# **The Status of ITER;** **The ITER Design Review**

**Town Hall Meeting on ITER – APS Conference  
Orlando 13<sup>th</sup> November 2007**

**ITER Design Review Coordinator  
G. Janeschitz**

# Shape Control

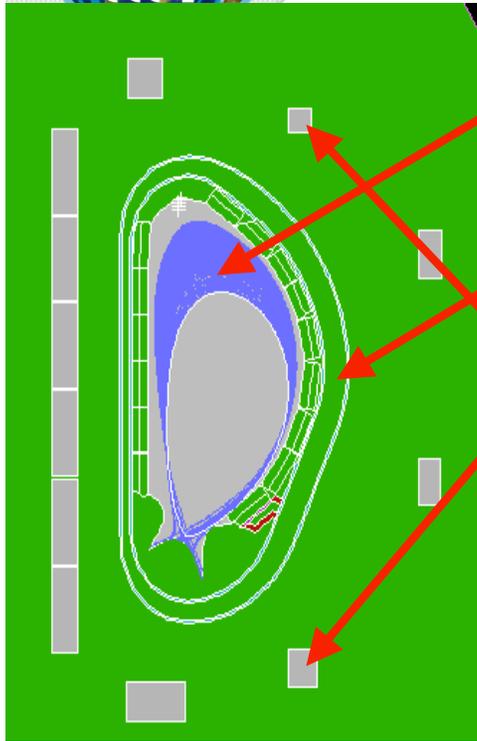
- operation with  $I_i < 0.8$  hits the limit on magnetic field on PF6 (5.9 T) and operation with  $I_i < 0.75$  hits the limit on current in PF2 (44 kA).
- operation with  $I_i < 0.75 - 0.8$  requires more difficult plasma shape feedback control (control of 7 plasma-wall gaps, instead of 6 gaps, without using of PF6 and PF2).

- operation with  $I_i < 0.75$  hits the limit on current in PF6 (49 kA) and operation with  $I_i < 0.65$  hits the limit on current in PF2 (44 kA).
- operation with  $I_i < 0.65 - 0.75$  requires more difficult plasma shape feedback control (control of 7 plasma-wall gaps, instead of 6 gaps, without using of PF6 and PF2).

- Change conductor in PF6 to **Nb<sub>3</sub>Sn**, => up to 20% increase of **current possible**
- Increase capability of PF2 and PF5 by 10% by adding winding packs
- *The total cost of these changes would amount to ~ 8.4 M€ - estimate of EU team – supported by ITER magnet division*
- *IO did not agree to these changes, wants to sub cool to 3.8 K*
- *However, sub-cooling was foreseen as mitigation of a coil failure*
- **STAC asks for change => study by risk assessment group**

## Vertical Stability

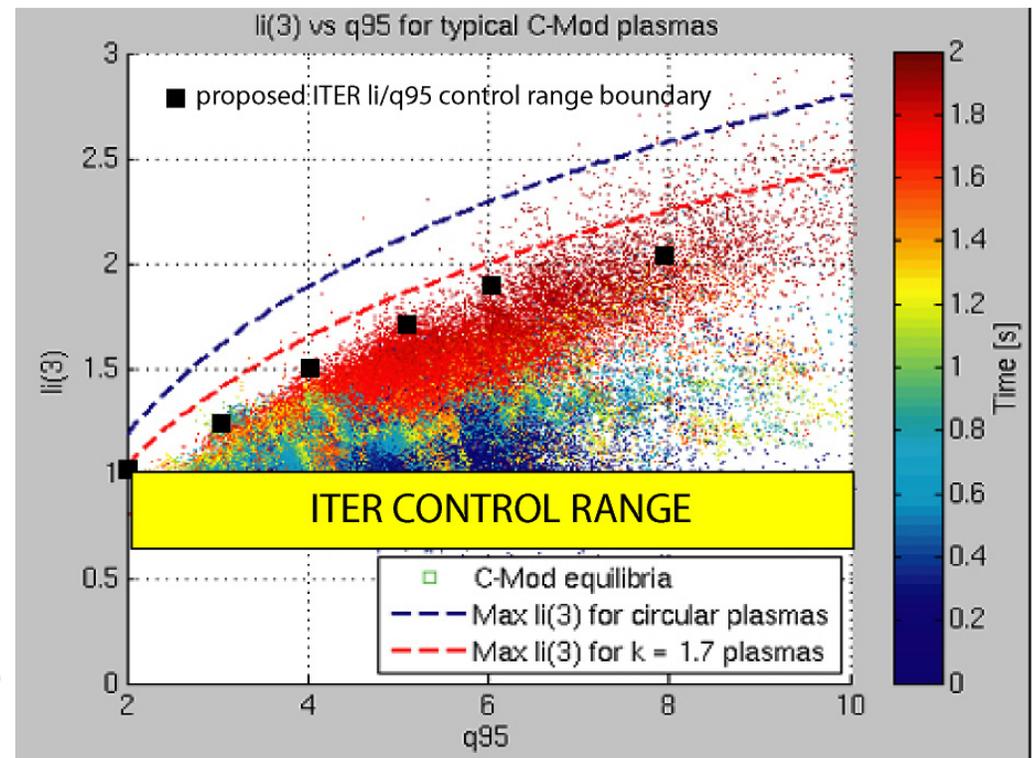
➤ The range of  $l_i(3)$  between 0.7 and 1.0 has been specified for the design of the ITER PF system

➤ There is a problem with vertical stability in most discharge phases but they are gravest in  $I_p$  ramp-up and ramp-down (high  $I_j$ )

# Solution: Improve Passive Stabilization

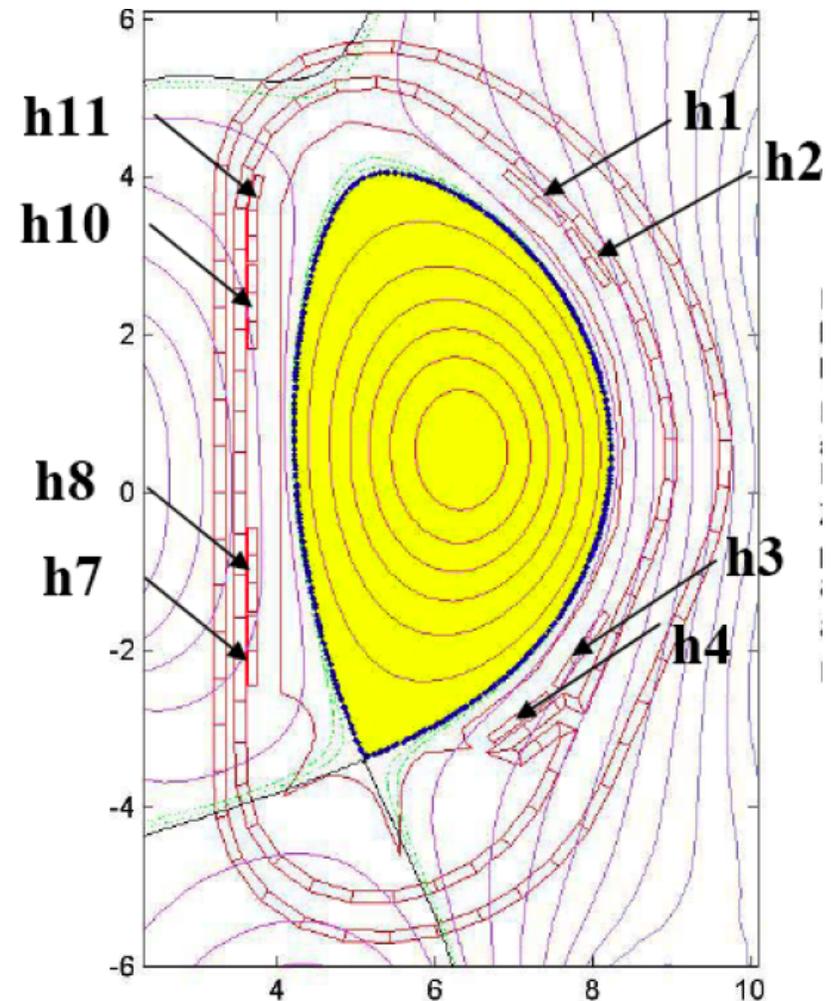
Connection of toroidal rings of blanket modules provides improved passive stability characteristics:

⇒ Studies of possible mechanisms for toroidal coupling of blanket modules

⇒ Analysis of disruption forces

⇒ Analysis of equilibrium/ control implications

⇒ Option of increasing voltage in PF coils from 6 to 9kV rejected by IO

# Flux Available for Burn in ITER

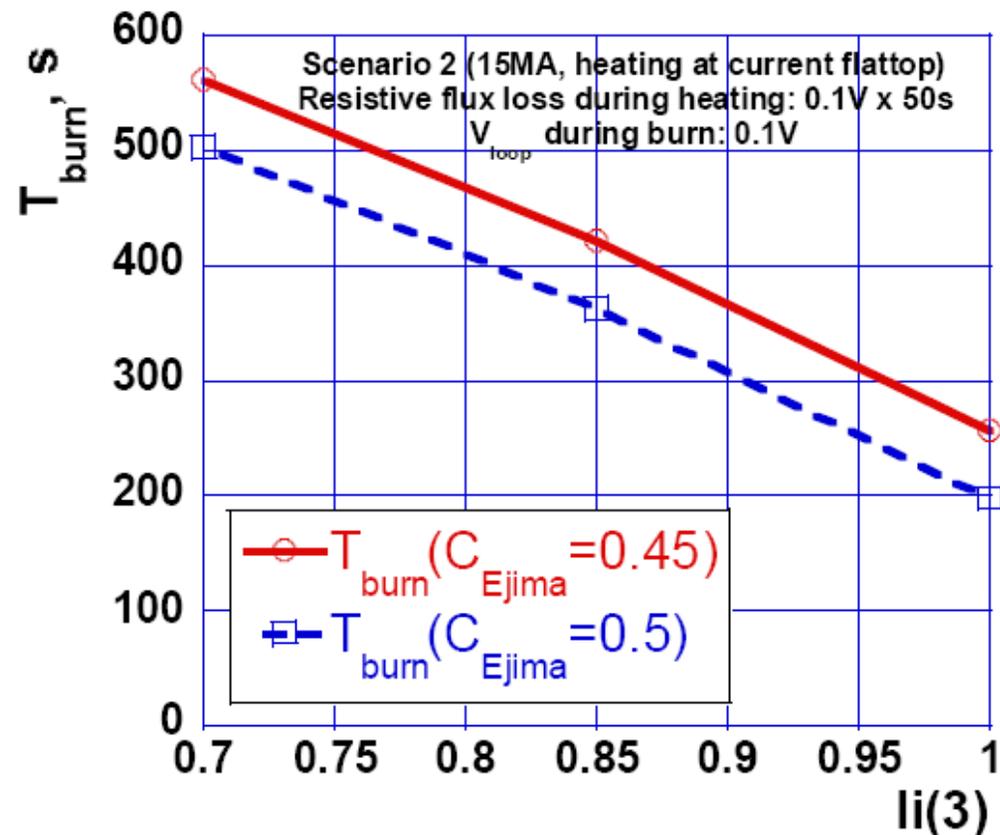
At high  $I_i$  during current ramp potentially no flux left for flat top

**Difficult approach to ITER reference scenario**

Possibly mitigation by increasing flux by ferromagnetic insert in the solenoid and by increasing resistivity in VV

Not yet studied by IO

**Most likely solution is early X-point formation and possibly to heat the plasma during current rise => PF upgrade**

# ELM Control Coils options studied

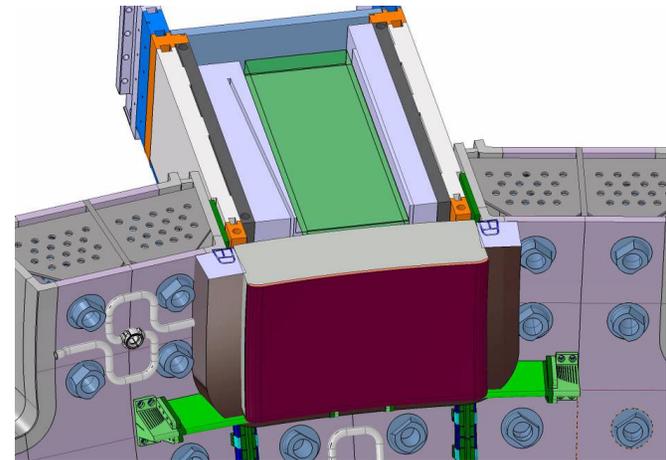
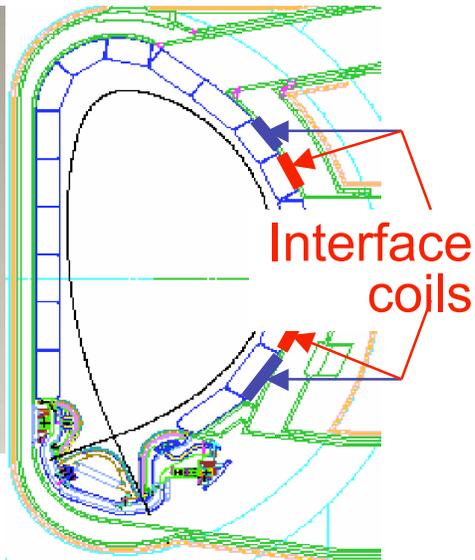
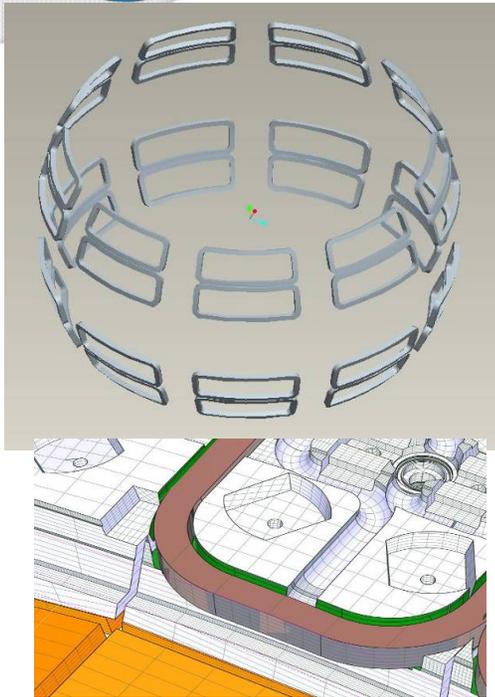
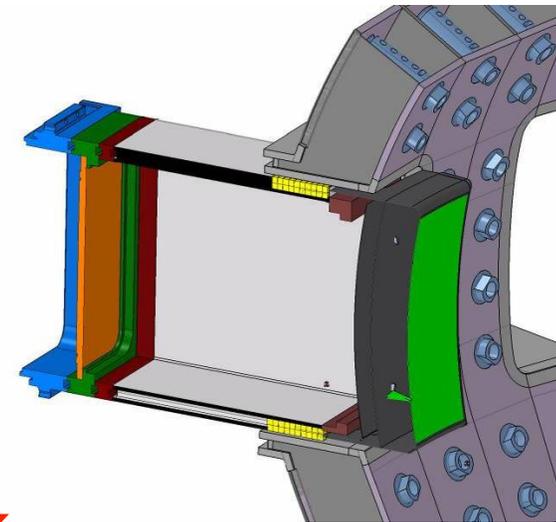
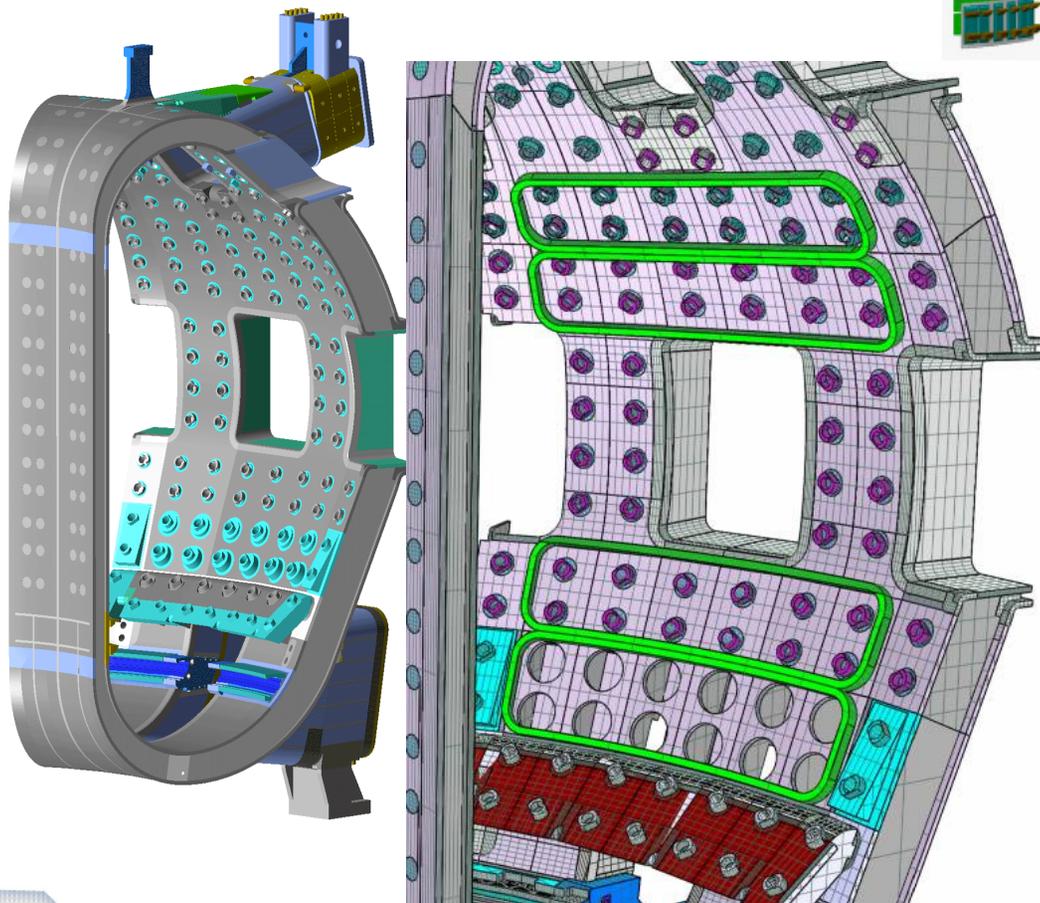
Three concepts studied by WG1 and costed by IO

Only 36 coil option will most likely work change location to between VV shells

# Vacuum Vessel – ELM coils between shells

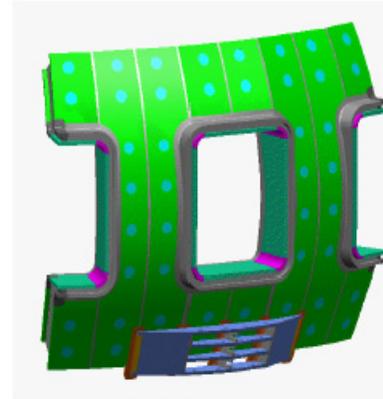
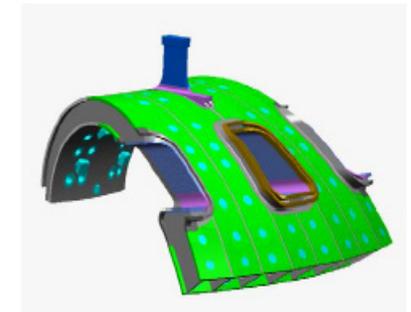
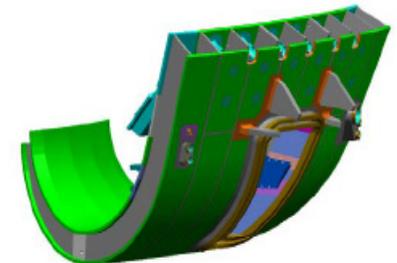
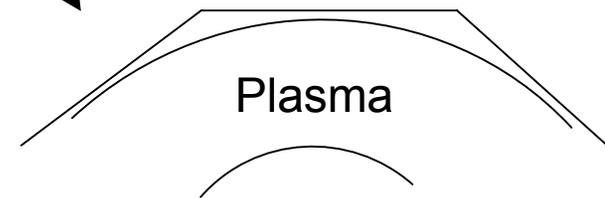
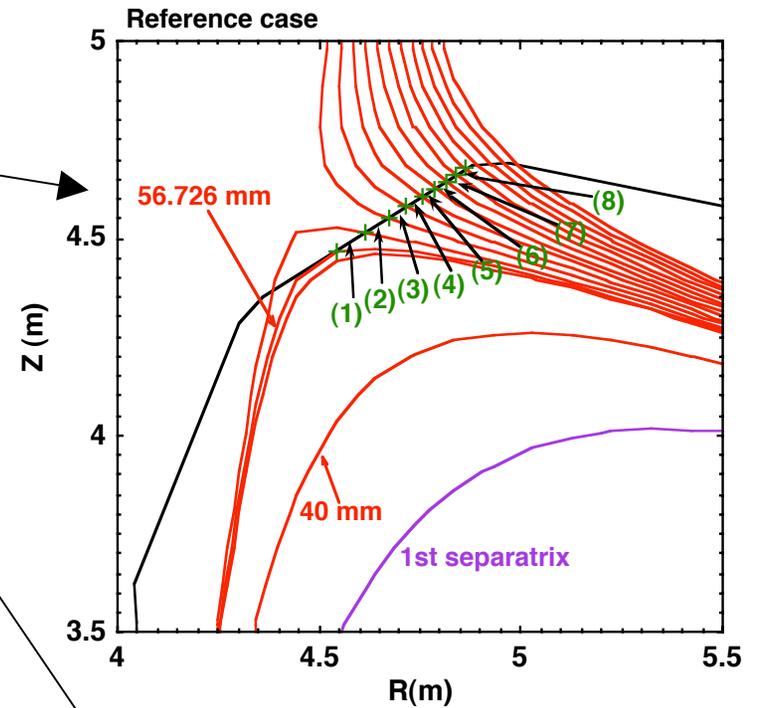
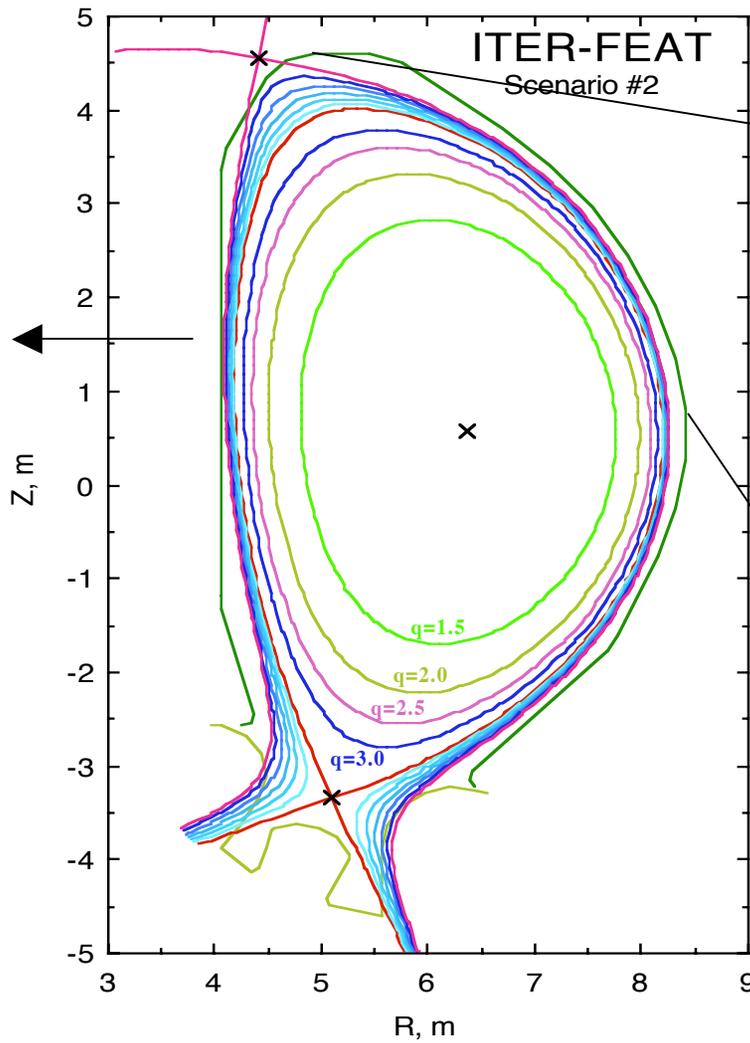
**STAC ask for this study until their next meeting**

**A working group (IO, EU, US, KO) will study this option**

**Conceptual design to be available until end of February**

**Then check schedule – cost- and safety impact**

# WG 5 – blanket manifold

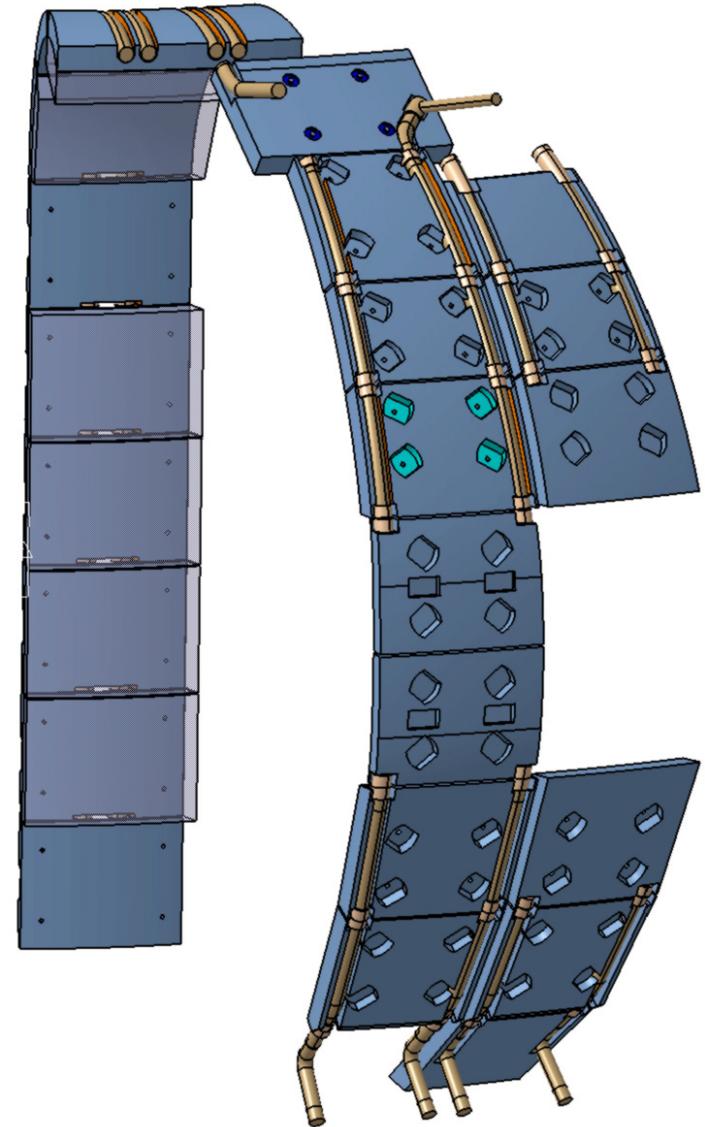
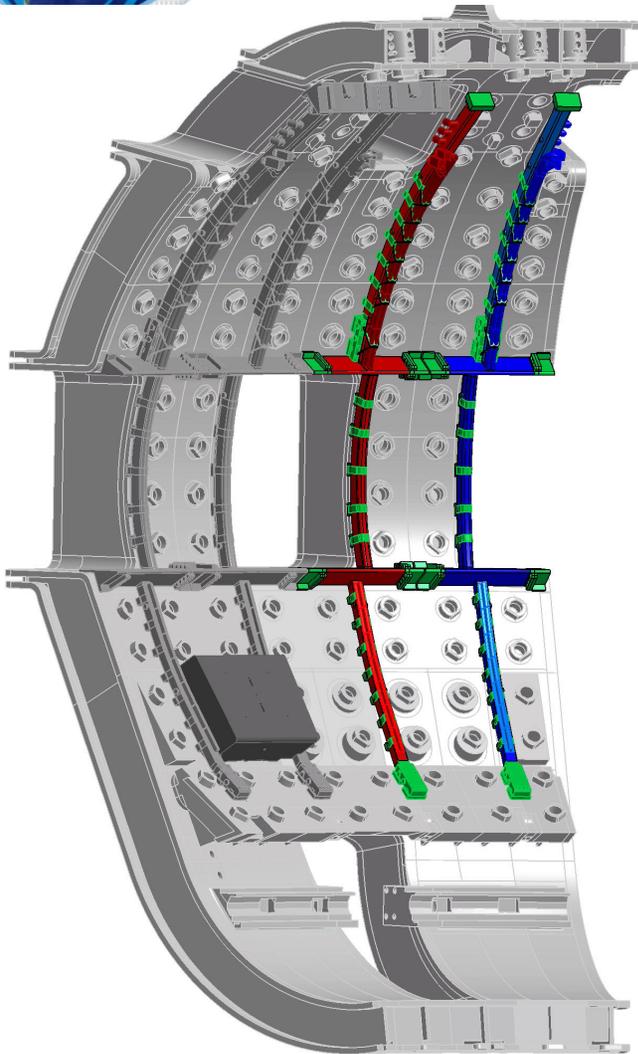
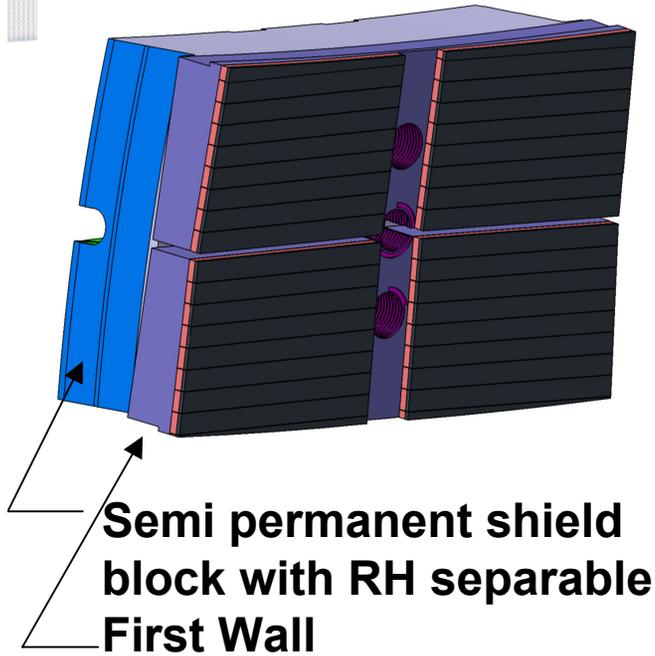
- Cooling water manifold is not RH compatible
  - Improve design or integrate the manifold into the blanket modules

Alternative concept

# Integrated Blanket Manifold

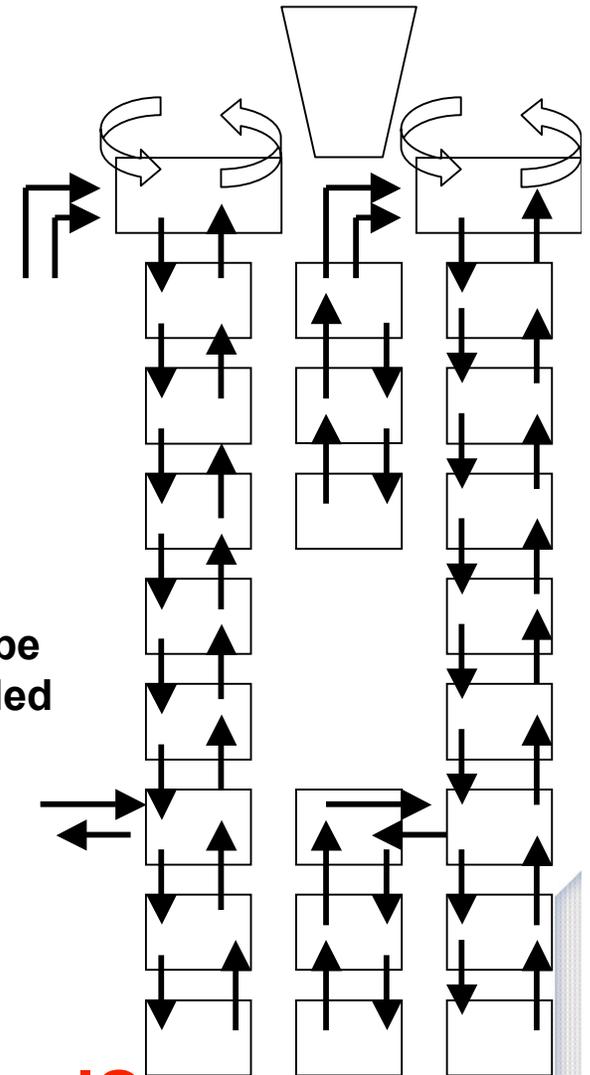
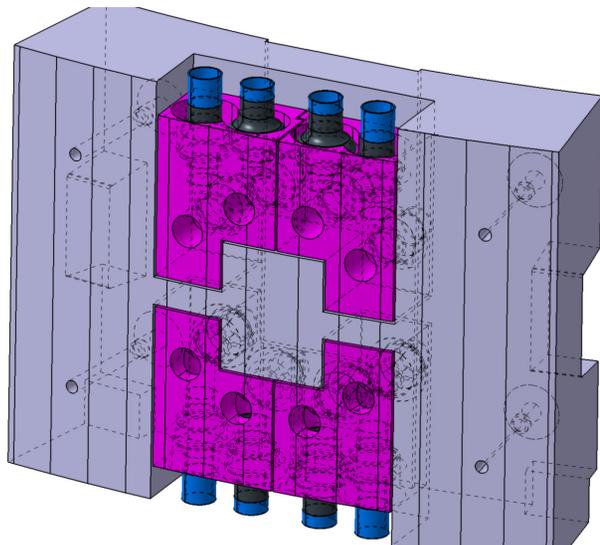
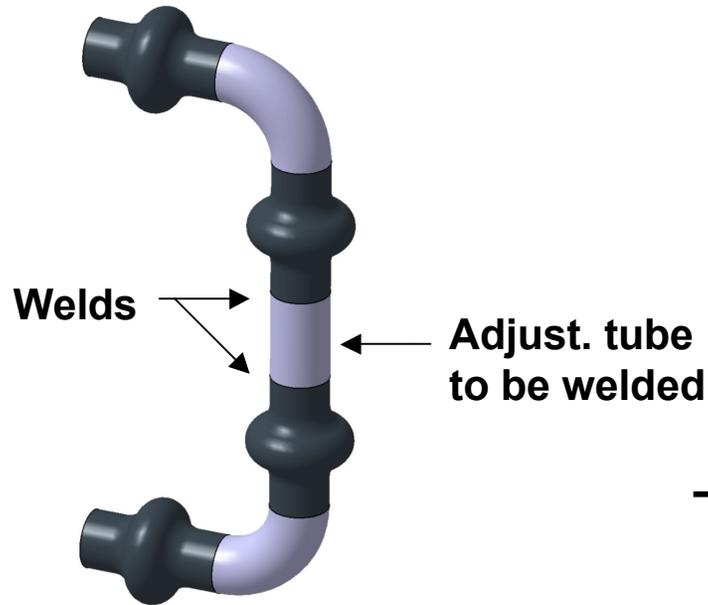
4 Single convolution branching pipe (PH. Rebut) connecting neighbouring shield blocks

**Not yet accepted by the IO**
